<p>CARNEGIE FORUM 305 WEST PINE STREET LODI, CALIFORNIA</p>	<p>AGENDA LODI SITE PLAN & ARCHITECTURAL REVIEW COMMITTEE</p>	<p>REGULAR SESSION WEDNESDAY, OCTOBER 22, 2014 @ 5:15 PM</p>
---	--	--

CITY OF LODI
SITE PLAN AND ARCHITECTURAL REVIEW COMMITTEE
Staff Report

CITY OF LODI
SITE PLAN AND ARCHITECTURAL REVIEW COMMITTEE
Staff Report

CITY OF LODI
SITE PLAN AND ARCHITECTURAL REVIEW COMMITTEE
Staff Report

SITE MAP

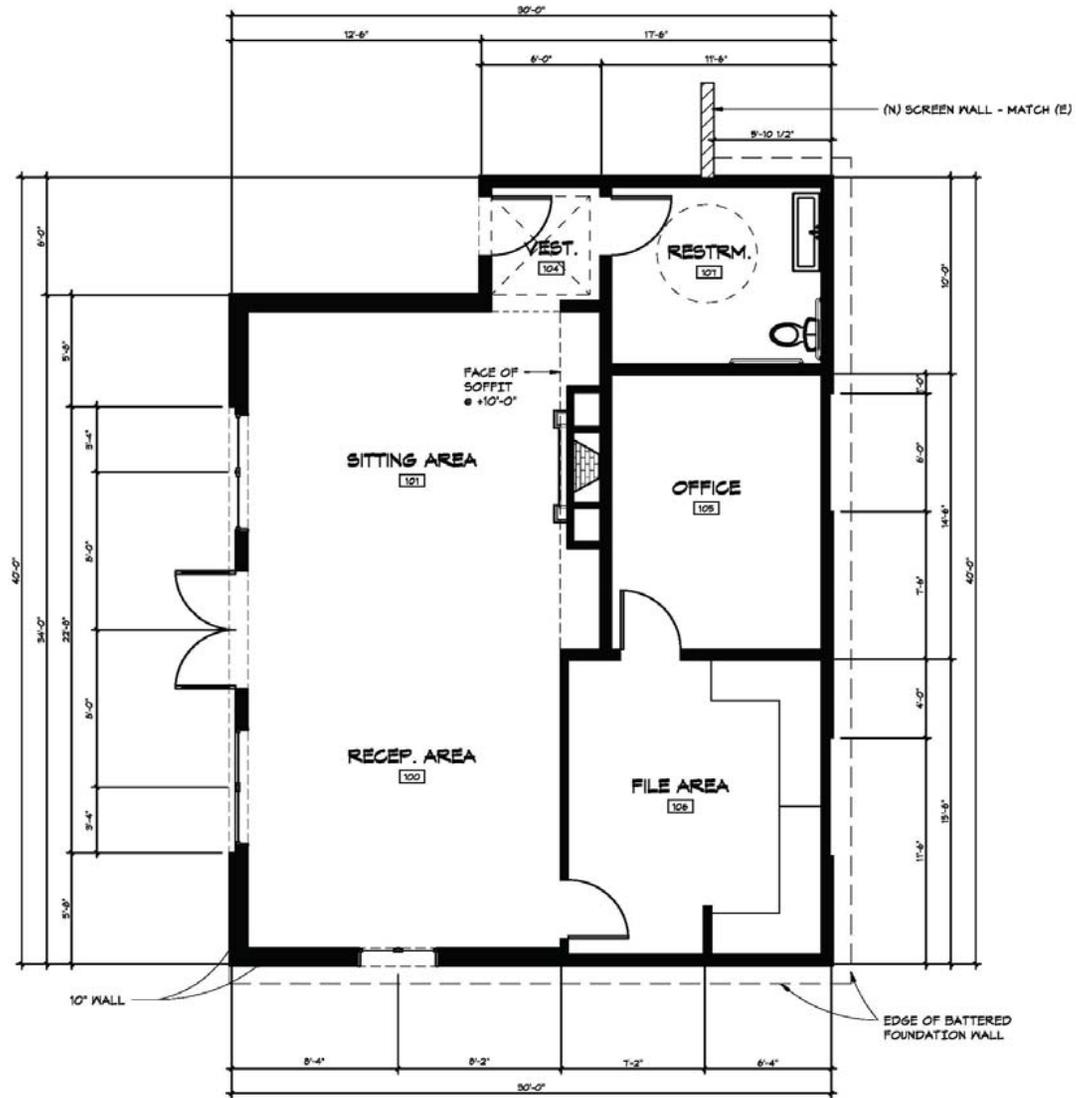
14. The Site Plan appears to show the new Lobby Building and the existing Historic Inn building located approximately 10' from each other. 2013 CBC, Section 705.3 states for the purposes of determining the required wall and opening protection and roof-covering requirements, buildings on the same lot shall be assumed to have an imaginary line between them. Provide the required fire separation distance between each structure and the imaginary line between the buildings as specified by the 2013 CBC, Table 602. Or, provide the required fire rated protection of walls, limitations of protected and unprotected openings for each building, as per 2013 CBC, Sections 705.3, 705.5, 705.8, 705.11, 716.5, Tables 601, 602 ,705.8 and 716.5 Or analyze the structures as portions of the same building as allowed by 2013 CBC, Sections 503.1.2 and the exception in 705.3.

15. Site Plan to show all building entrances and all ground level exits shall be connected on an accessible route to other buildings on the site, public transportation stops, accessible parking and passenger loading zones and to public streets and sidewalks. 2013 CBC, Sections 11B-206.1, 11B-206.2.1, 11B-206.2.2, 11B-206.2.4, 11B-206.4, 11B206.4.1.1, 11B-Division 4

17. The indentation of the driveway near the stairs appears to be a passenger drop-off zone. The passenger drop-off is required to have an accessible passenger drop-off and loading zone access aisle in compliance with 2013 CBC, Section 11B-503. The plans shall specify and show: 1) a vehicular pull-up space that is a minimum 96" wide and minimum 20' long, 2) the access aisle to be a minimum 60" wide and shall be the full length of the vehicle pull-up space it serves, 3) the access aisle shall be marked with a painted borderline around the perimeter and the area within the borderline shall be marked with hatched lines @ a maximum 36"oc in a color that contrasts with the access aisle surface, 4) the vehicular pull-up space and the access aisle shall be at the same level and shall not exceed 1:48 (2%) slope in any direction, 5) the passenger loading zone shall be identified with a reflectorized sign, in compliance with Section 703.5, stating "Passenger Loading Zone" and shall include the International Symbol of Accessibility, in white on a blue background. The sign shall be posted adjacent to and visible from the passenger loading zone. The sign's visual characters shall be a minimum of 40" above the ground or walking surface. Signs located in the accessible path of travel shall be a minimum of 80" above the walking surface, measured from the bottom of the sign. In addition, the passenger drop-off access aisle shall be included in the accessible path of travel to the building entrance as per Comments #4 and #5 above.

18. Plans to specify and show accessible parking spaces in compliance with 2013 CBC, Sections 11B-208.2, 11B-502 and Table 11B-208.2. At least one space shall be van accessible as per 2013 CBC, Section 11B-208.2.4.
